# Access Compliance Report

## Public Rights-of-Way

Intersection ID: 6171	Main Street: AMHERST_GLEN_DR	Cross Street: ATKINS_RIDGE_DR	Location: NE
ADA ID: 43C9B9715D4A	Ramp Type: Perp	Initial Pass/Fail: Fail	Overall Compliance: No
Severity Score: 22.5			
Codes/Mitigation Info/Possible Solution		Field Measurements/Component Compliance

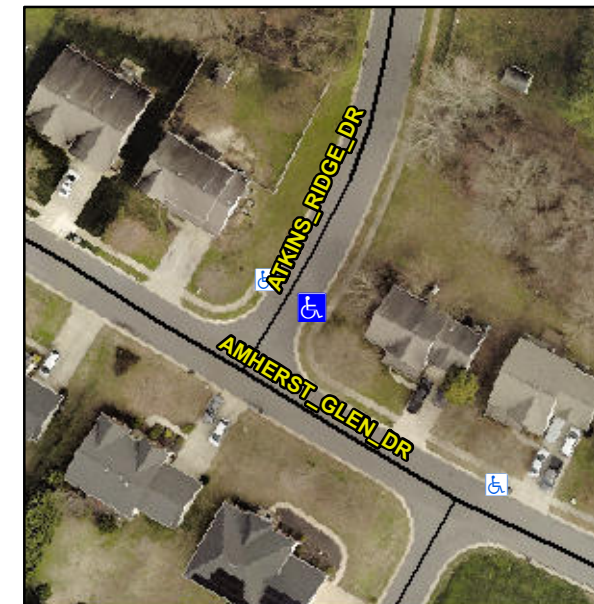
**Not Found, R304.5.1, R304.2.2, R304.5.3**

Compliance	Description	Data	Compliance	Description	Data
N/A	Ramp Length (in)	48.0	No	Ramp Slope (%)	11.8
No	Ramp Width (in)	36.5	No	Ramp XSlope (%)	3.7
N/A	Flare Type LT	N/A	N/A	Flare Type RT	N/A
N/A	Flare Slope LT (%)	N/A	N/A	Flare Slope RT (%)	N/A
N/A	Flare Traversable LT?	N/A	N/A	Flare Traversable RT?	N/A
N/A	Landing Length (in)	N/A	N/A	DWS Provided?	N/A
N/A	Landing Width (in)	N/A	N/A	DWS Contrast?	N/A
N/A	Landing Slope (%)	N/A	N/A	DWS Length (in)	N/A
N/A	Landing X Slope (%)	N/A	N/A	DWS Full Width?	N/A
N/A	Landing Curb? (Y/N)	N/A	N/A	DWS Offset (in)	N/A
N/A	Shared Landing?	N/A			
N/A	Gutter Ponding?	N/A	N/A	Gutter Slope (%)	N/A
N/A	Gutter Lip Ht (in)	N/A	N/A	Gutter X Slope (%)	N/A
N/A	Painted X Walk1?	No	N/A	Painted X Walk2?	N/A
	X Walk 1 Direction	To NW		X Walk 2 Direction	N/A
N/A	X Walk 1 Width (in)	N/A	N/A	X Walk 2 Width (in)	N/A
	X Walk 1 Slope (%)	2.6		X Walk 2 Slope (%)	N/A
	X Walk 1 X Slope (%)	4.0		X Walk 2 X Slope (%)	N/A

**Remove & Replace Entire Ramp.**
